# TOWN OF WINDERMERE

## Town Council Workshop Minutes

March 3, 2022

Town of Windermere  
Proposed Downtown Property  
30% Civil Progress – Kimley- Horn Dated Feb. 18, 2022

Image 1

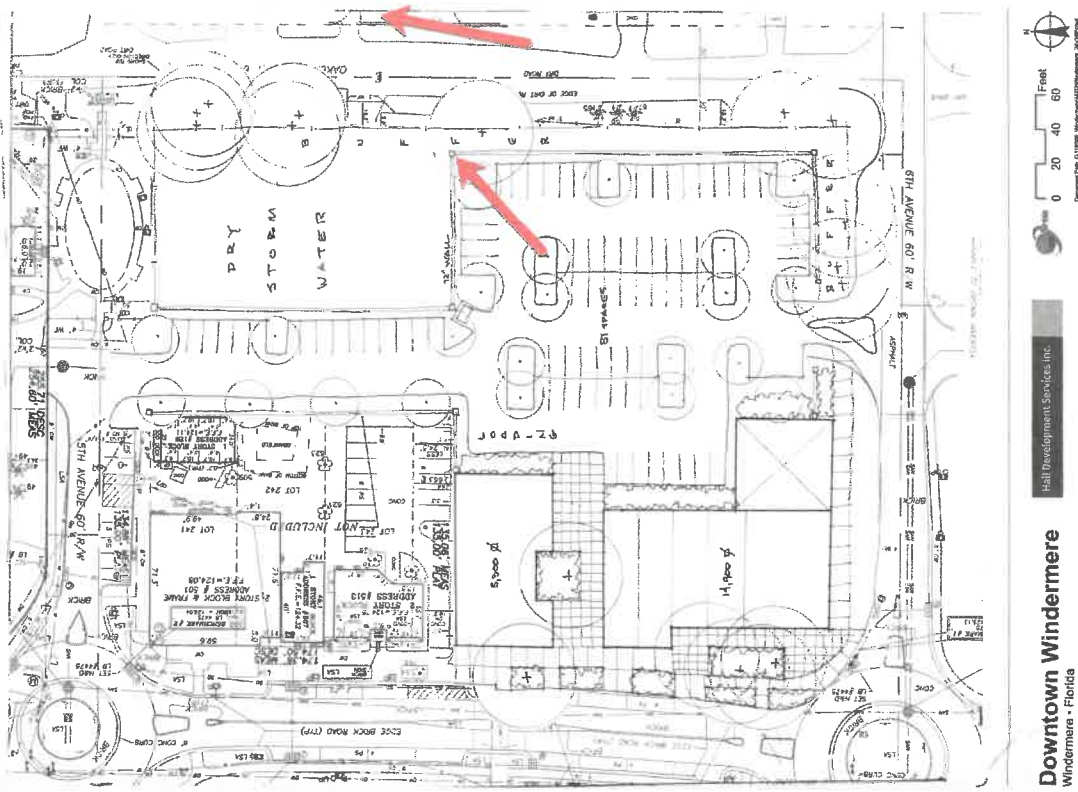
From several designs I have seen, the wall that is discussed in the above sentence does not look like it is going to be in front of/east of the "stormwater retention".

This is a very important distinction for me as my home, 515 Oakdale Street, is directly across from where this proposed "stormwater retention" will be located. I have small children and would like any "stormwater retention" to be behind both the landscape buffer and the 6 foot wall. The wall should go all the way down from the south end of the project by 6th Ave, moving North along Oakdale, to the "Civic Area".

These drawings indicate to me that the wall is going to stop about halfway down Oakdale and carve out the "stormwater retention" as to be on the outside of the wall and directly across from my home.

The first image is where the proposed wall is ending with red arrows indicating my home and the end of the wall. The second image is what I believe should be built, as it is stated in the Downtown Redevelopment Project website.
